**PARAMETERS & REGULATORY TEXT
UPDATE DOCUMENT**

SKIMMINGDISH LANE, BICESTER

ALBION LAND

September 2015

Drawing status - **FOR PLANNING**
 Client - **ALBION LAND**
 Project - **SKIMMINGDISH LANE BICESTER**
 Drawing title - **LANDSCAPE PARAMETERS PLAN**

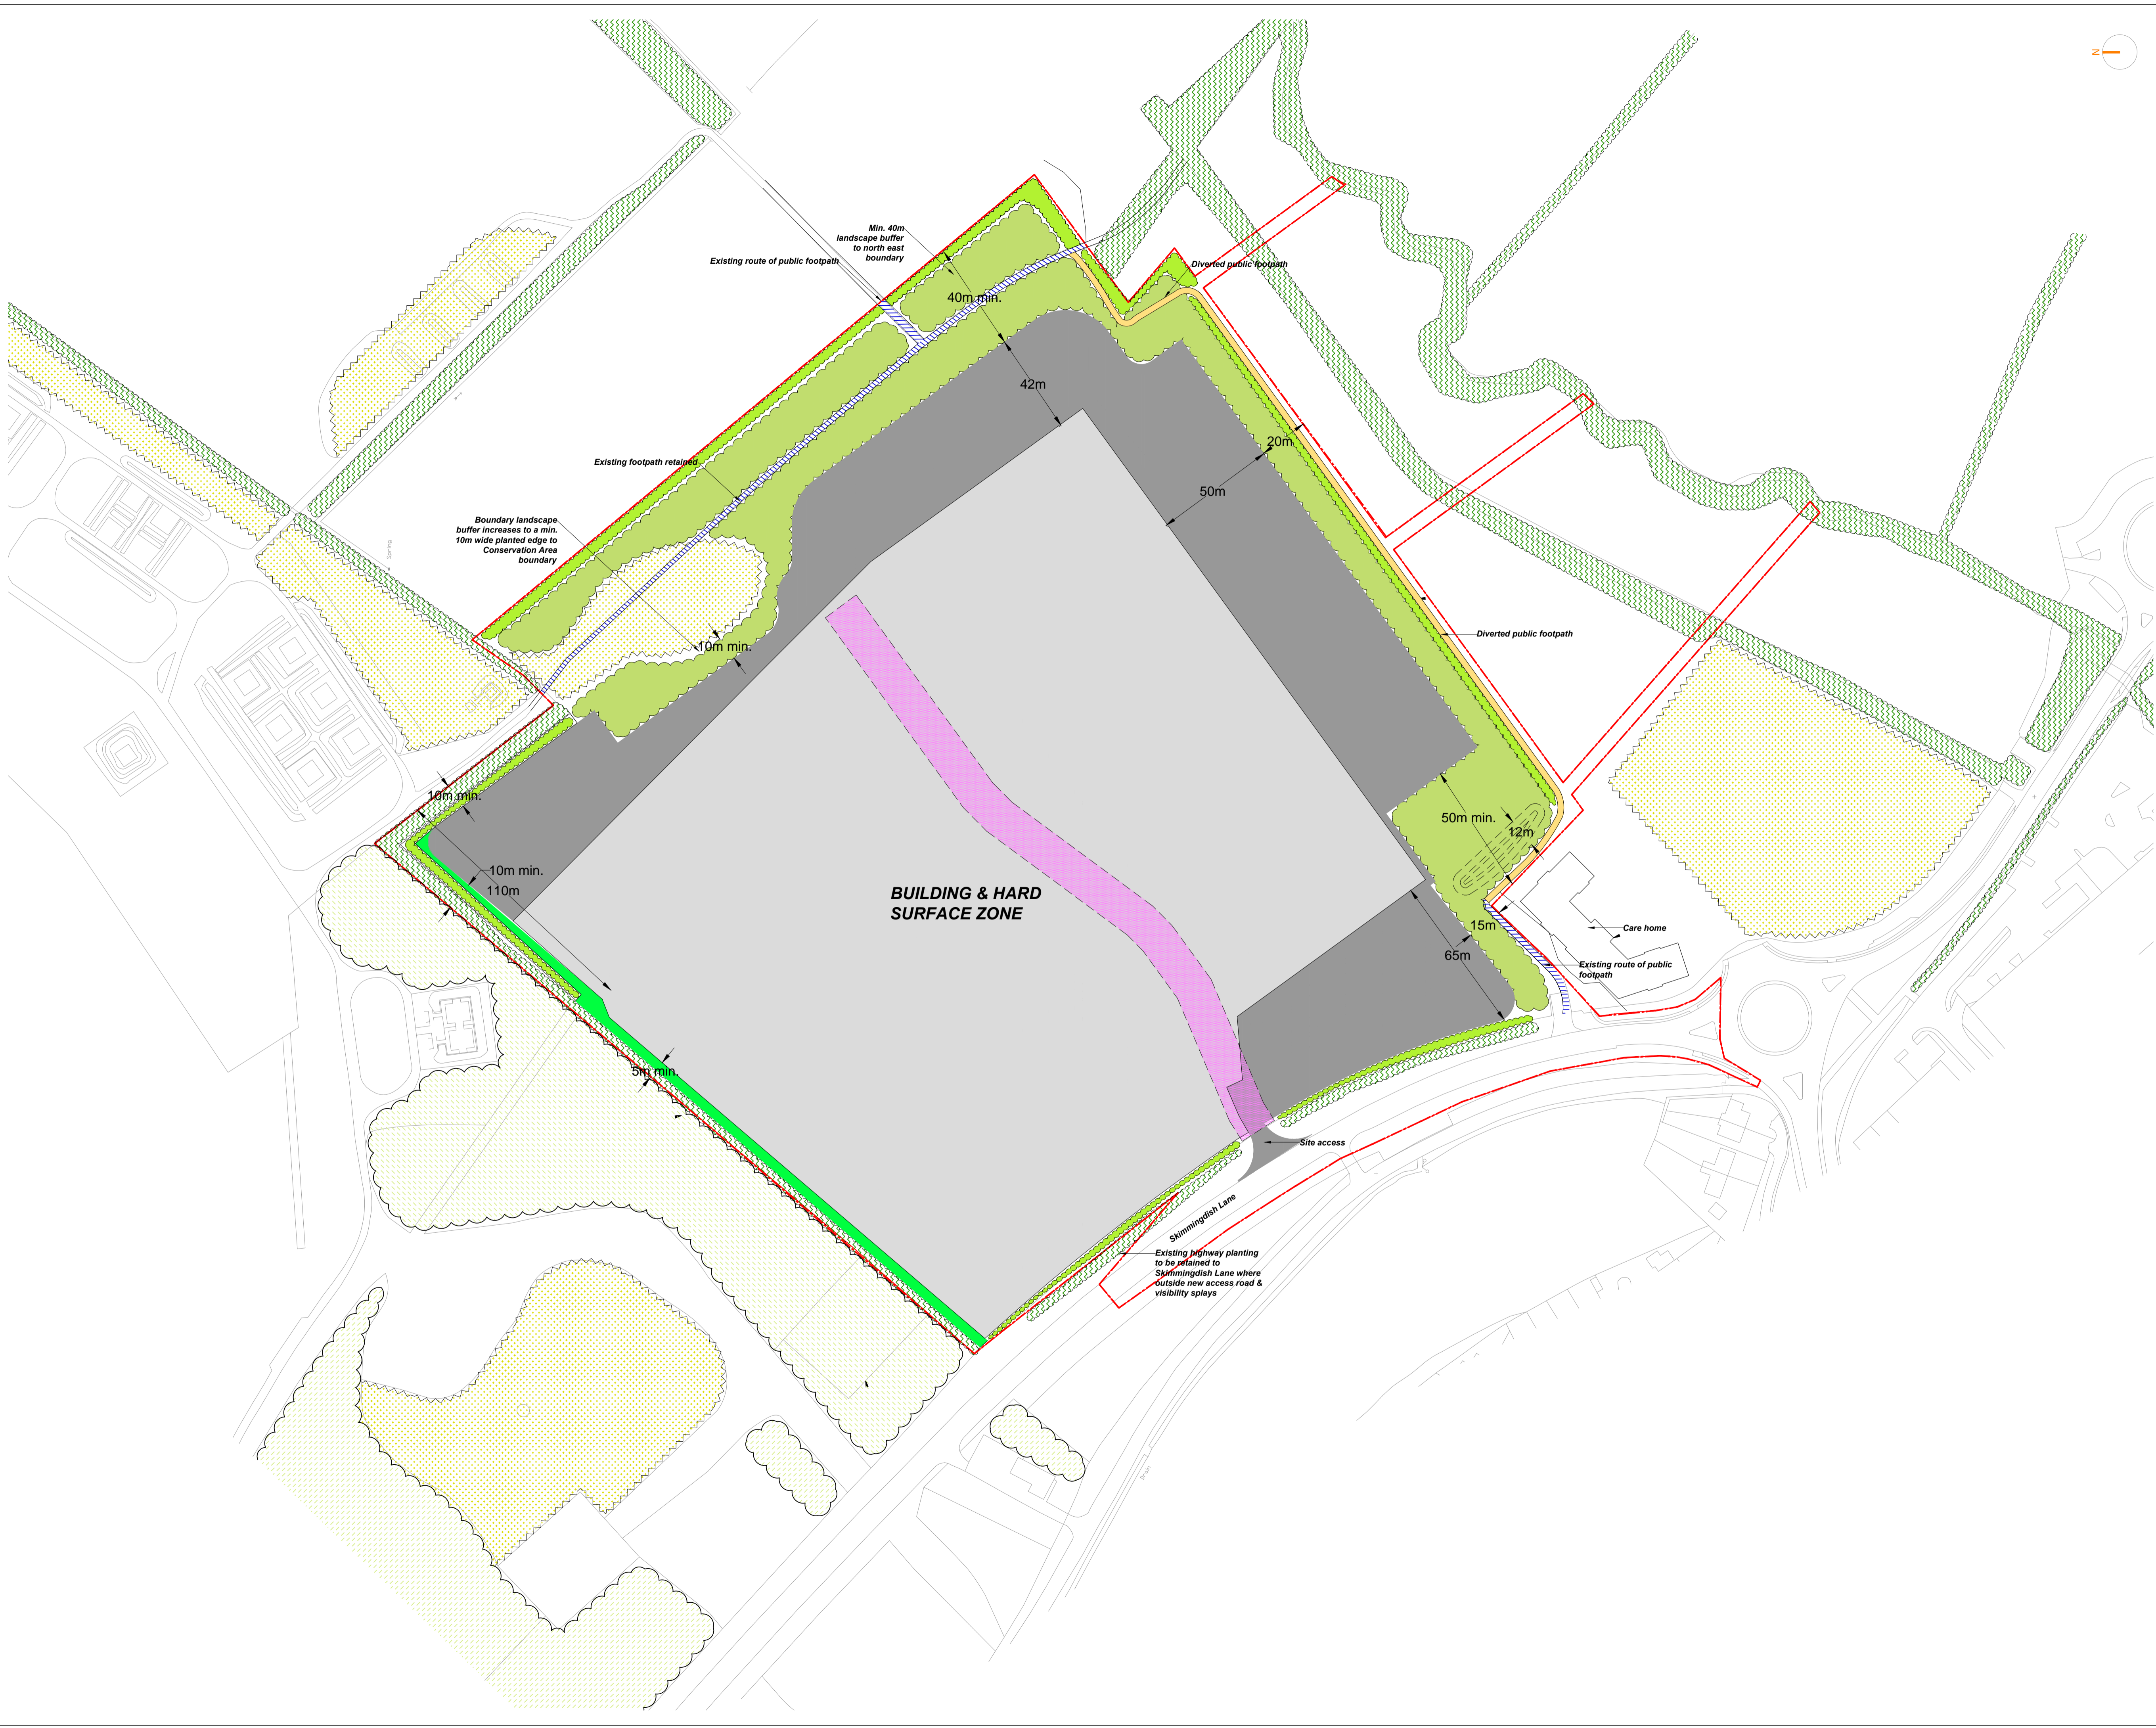
2.8 Landscape Parameters Plan ref RF14228L01D (see **Appendix 3**) includes the following details:

- The areas within the site which are to be retained or formed as landscaping zones. As with the original submission, these areas are expressed as minimums demonstrating the minimum set back distance of the development zones from the site boundaries or adjacent sensitivities.
- This parameter has been amended slightly in response to the pulling back of the built development area from the north western boundary in particular.

DATE	DRAWN	DESCRIPTION OF REVISION	REVISION LETTER	CHECKED BY
03.09.15	AF	Dense woodland belt extended to boundary	D	GD
18.08.15	AF	Site layout amended to new building zones	C	AF
14.08.15	AF	Additional labelling, site boundary changed	B	GD
12.08.15	AF	Building zones changed following comments	A	GD
